RE: Lycee Francais Renovation
1601 Leonidas Street
New Orleans, LA 70118
Proposal # 050

Cost Proposal Request

RFI Response 098

Request for Information # 98

1 FIRST FLOOR - DUCTWORK - PLAN
M2.1 1/8" = 1'-0"

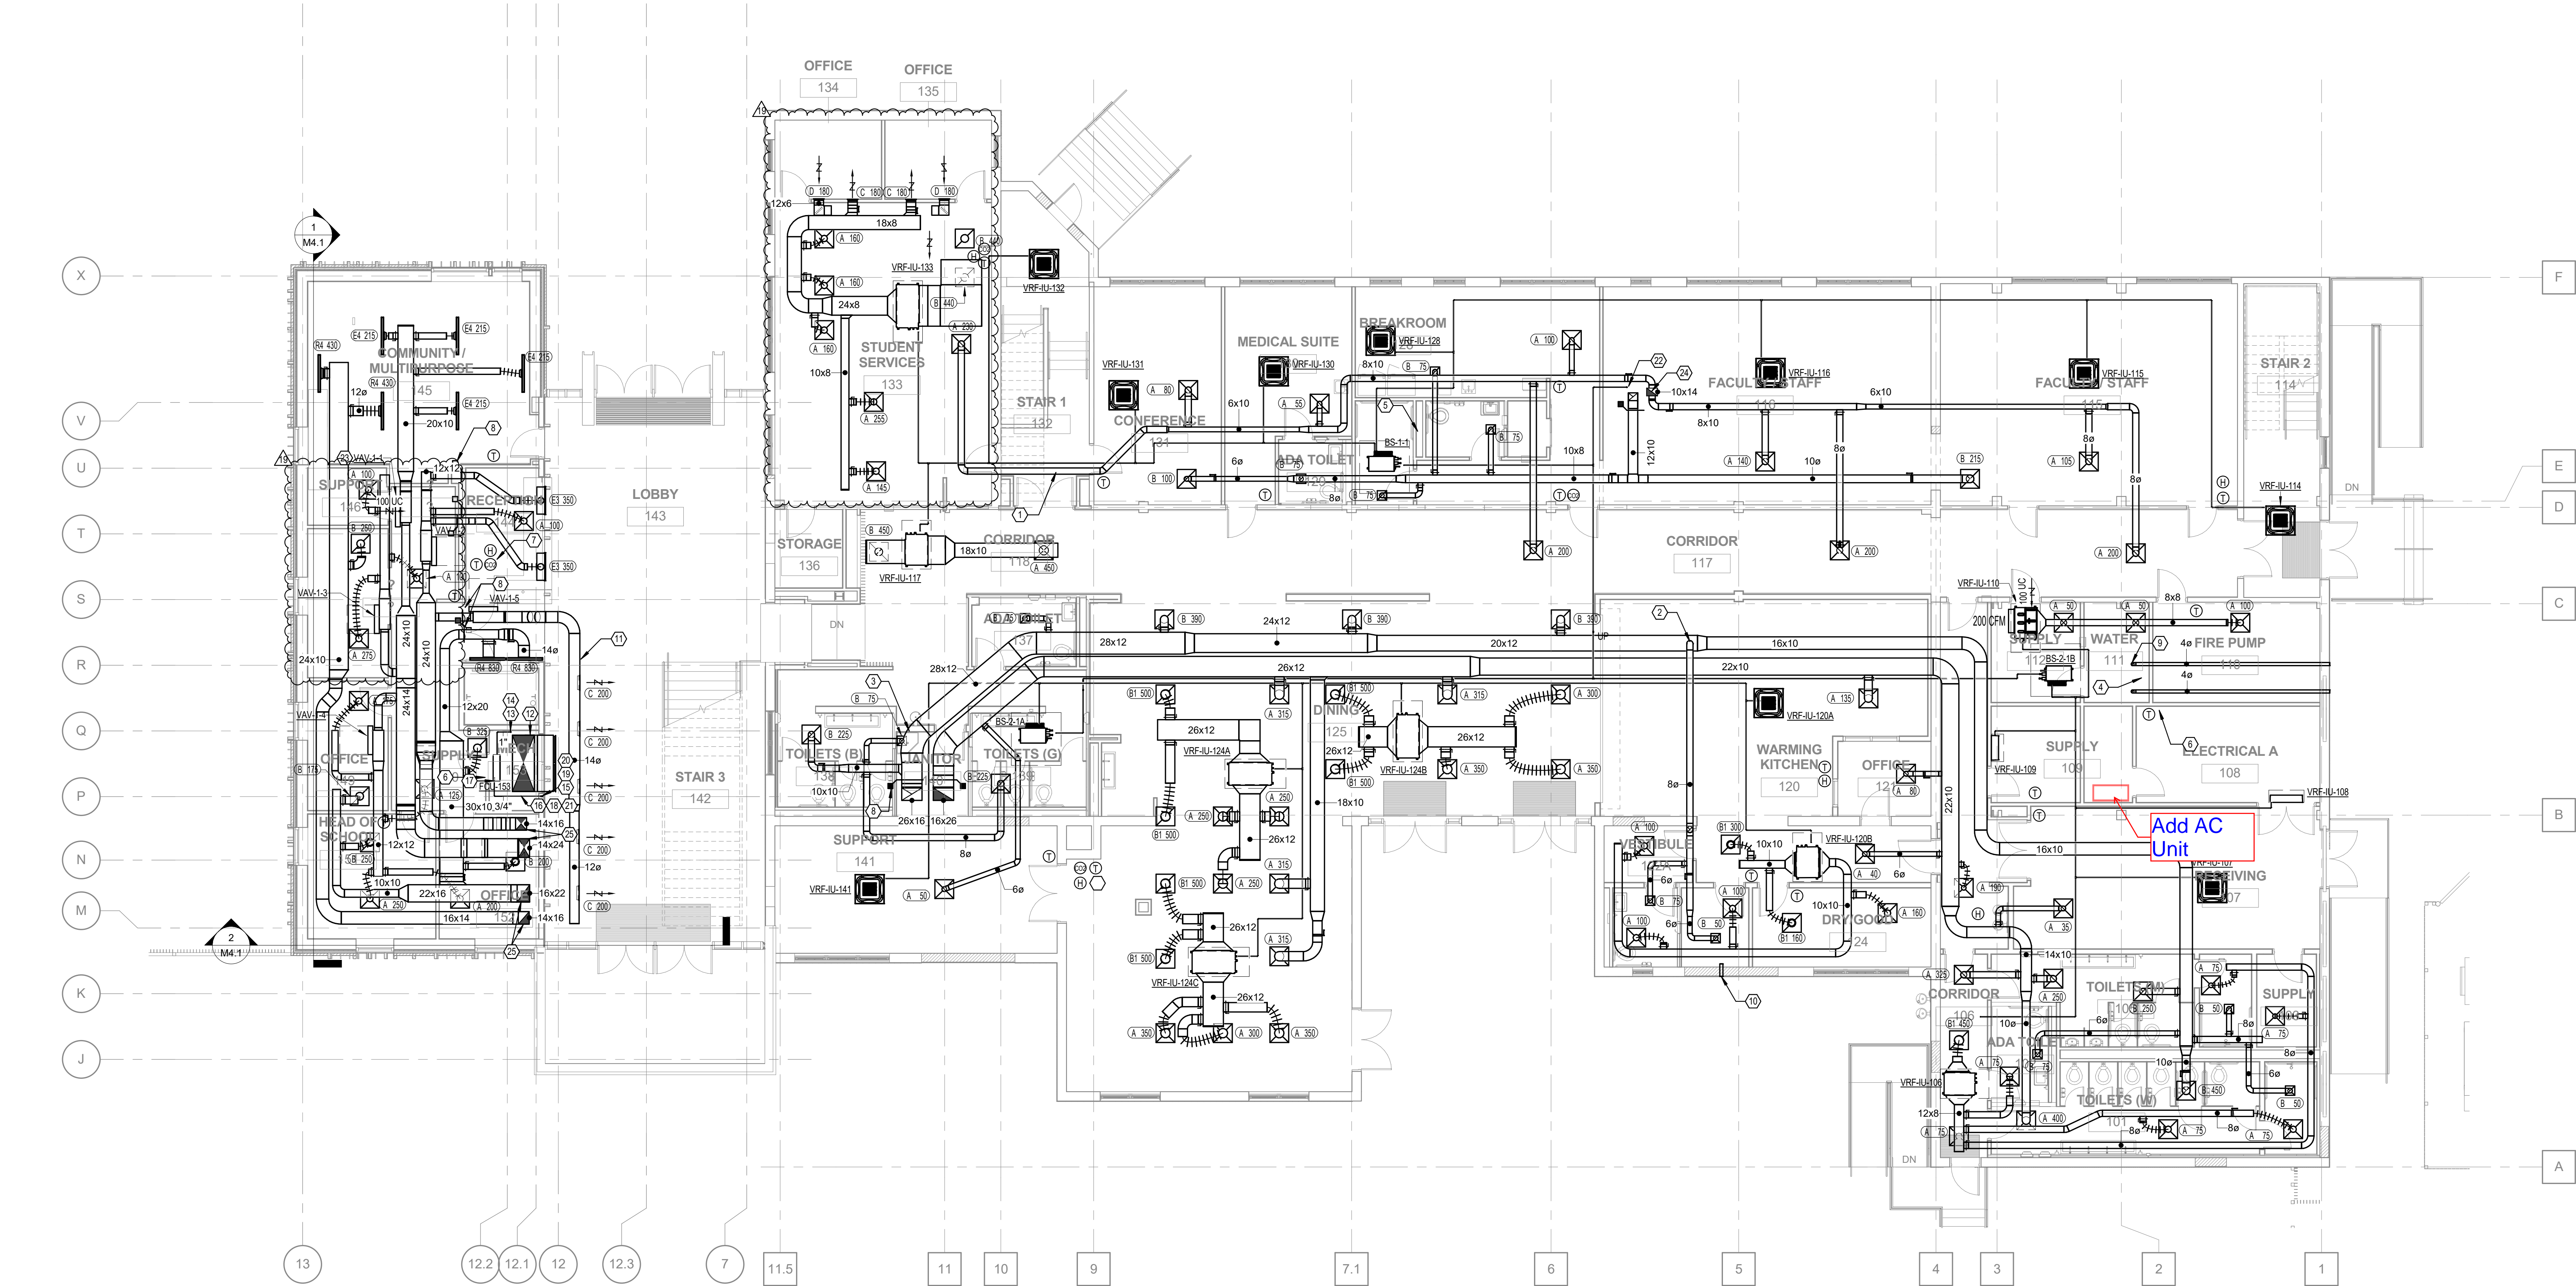
RFI Detail:
Please confirm if Electrical "B", room 108B, is to receive AC.

Install new AC unit in Electrical room 108B

WORK DESCRIPTION: Extdend circuit L1A- 65,67 to the location for the new AC unit in room 108B

1. Install wall mounted unit model number FXAQ07PVJU on plan east wall of Electrical room 108B and tie to branch selector BS-2-1B.

2. The power for the unit can be tied into the existing circuit feeding the other units in the area (L1A-65,67)
